Re: Can-Am™ Roadster – Fuel Cap Replacement

SAFETY
CAMPAIGN

December 21, 2012 Subject: **Can-Am™ Roadster - Fuel Cap Replacement** No. **2012-13**

PROCEDURE

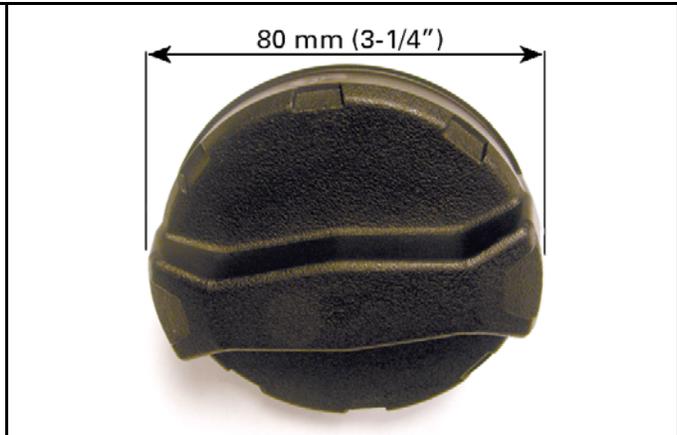
The fuel cap may not seal properly the fuel tank filler neck. Fuel vapors in the presence of an ignition source could result in a fire.

Remove and discard vehicle's fuel cap.

Install the new improved fuel cap.

NOTE: For reference, please see below pictures that will help you identify the new fuel cap which has a reddish color seal AND a different size handle.

Identification of new and improved fuel cap

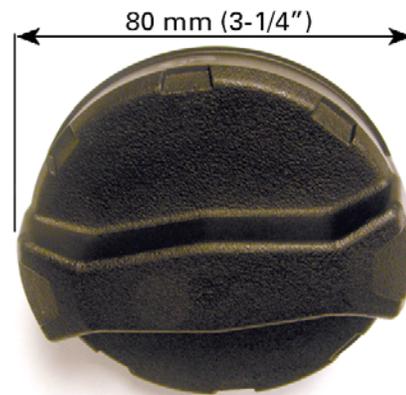
The fuel cap may not seal properly the fuel tank filler neck. Fuel vapors in the presence of an ignition source could result in a fire.

Install the new and improved fuel cap provided in this box and discard the old one. If you had the fuel cap replaced at your own expense before you received this letter, you may be eligible to receive reimbursement for the cost of obtaining a pre-notification remedy of the problem associated with this recall.

For reference, please see below pictures that will help you identify the new fuel cap which has a reddish color seal AND a different size handle.
